Docket No. 50-336

Millstone Nuclear Power Station, Unit No. 2

Proposed Revisions to Technical Specifications

January, 1982

Figure I - Affected Area Definition and Imperfection Distribution in Steam Generator No. 1

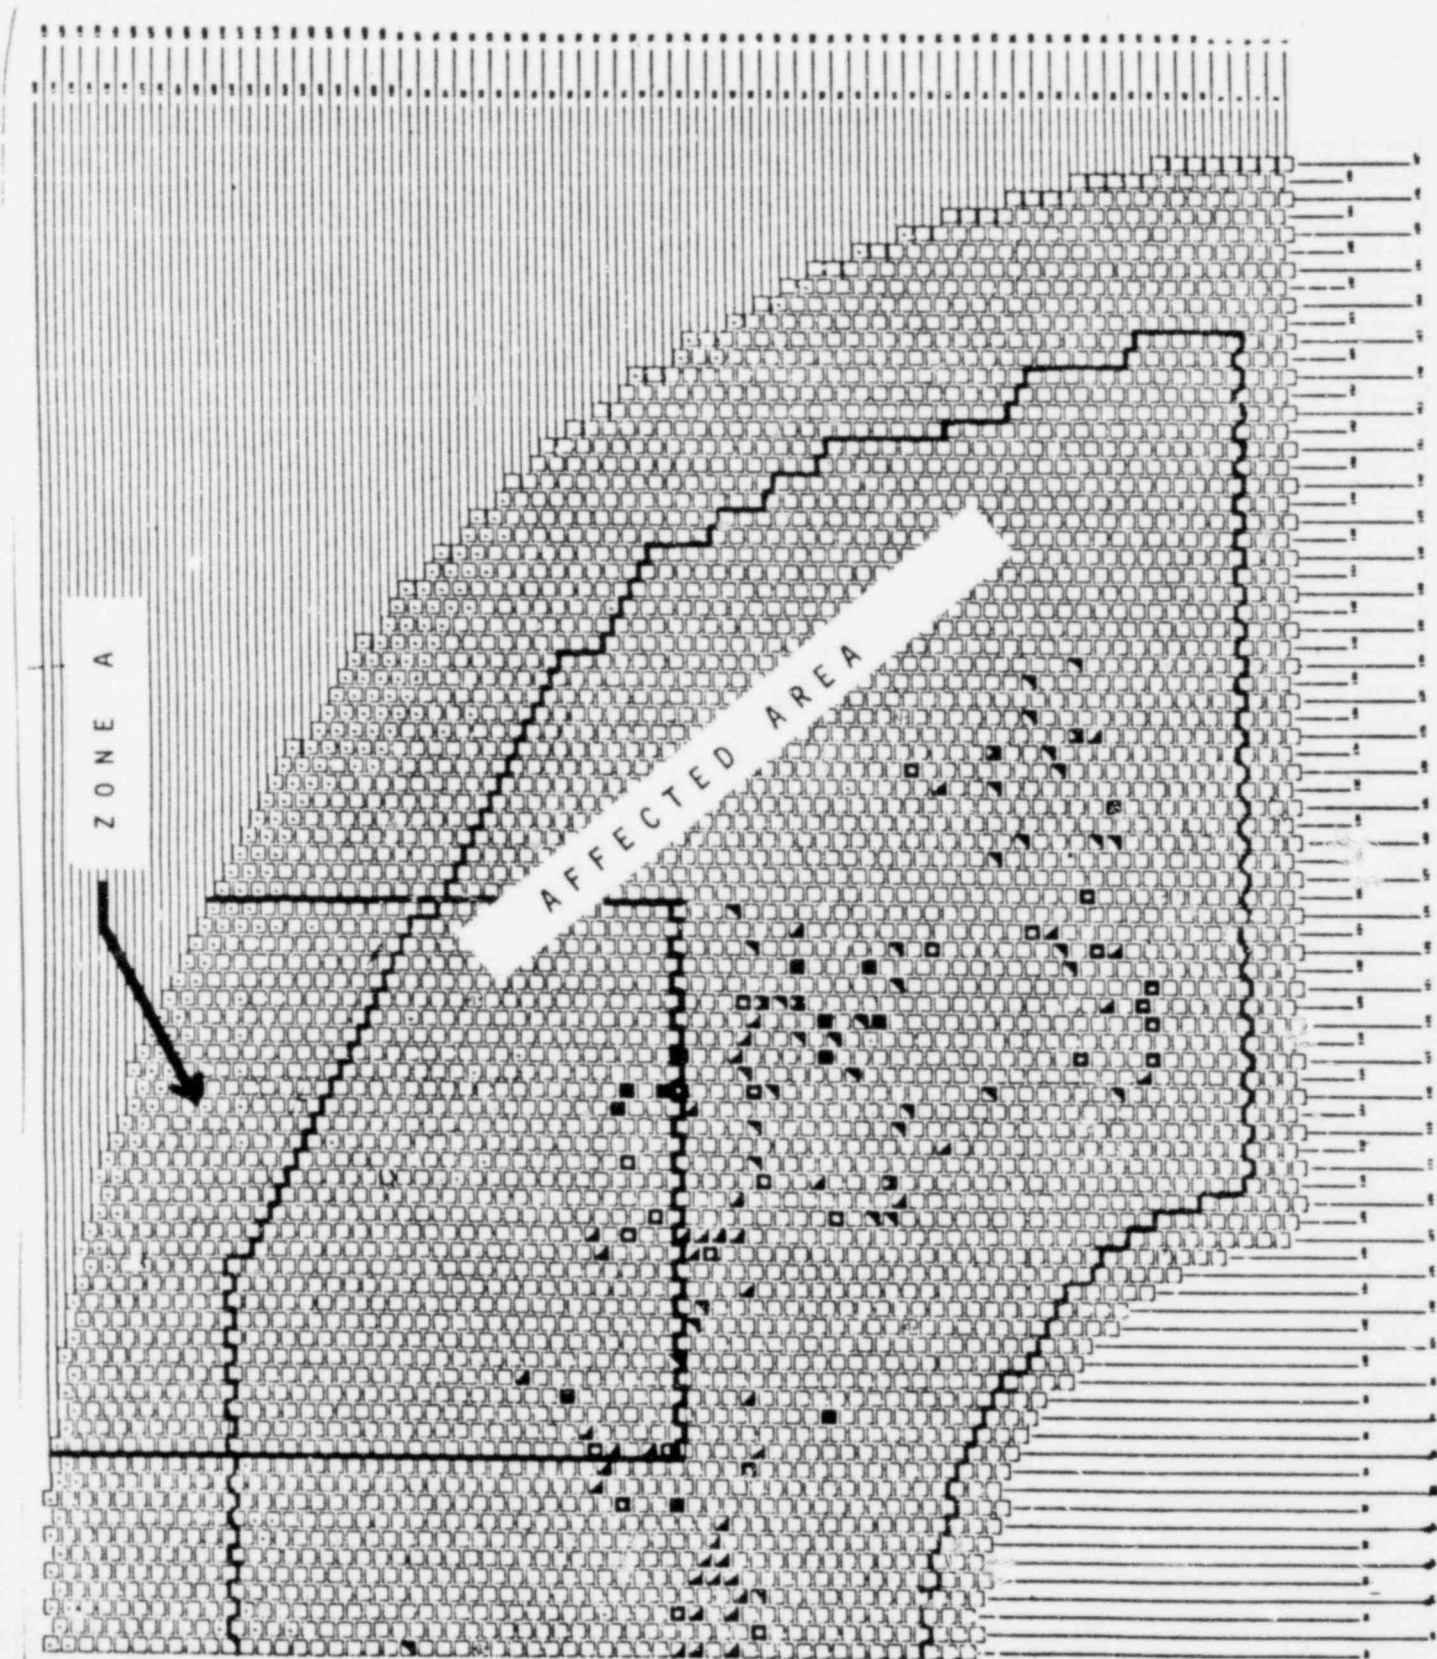
- (a) This Action Requirement does not apply to the Cycle 5 refueling outage inspection results. Action requirement for Steam Generator tube inspection result C-3 is to inspect all tubes in the affected area of both Steam Generators, between the tube sheet and the first tube support elevation, inlet and outlet sides and plug defective tubes. The affected area of the tube bundle is defined in Figures 1-4. This revised Requirement applies only to the Cycle 5 refueling outage Steam Generator inservice inspections.
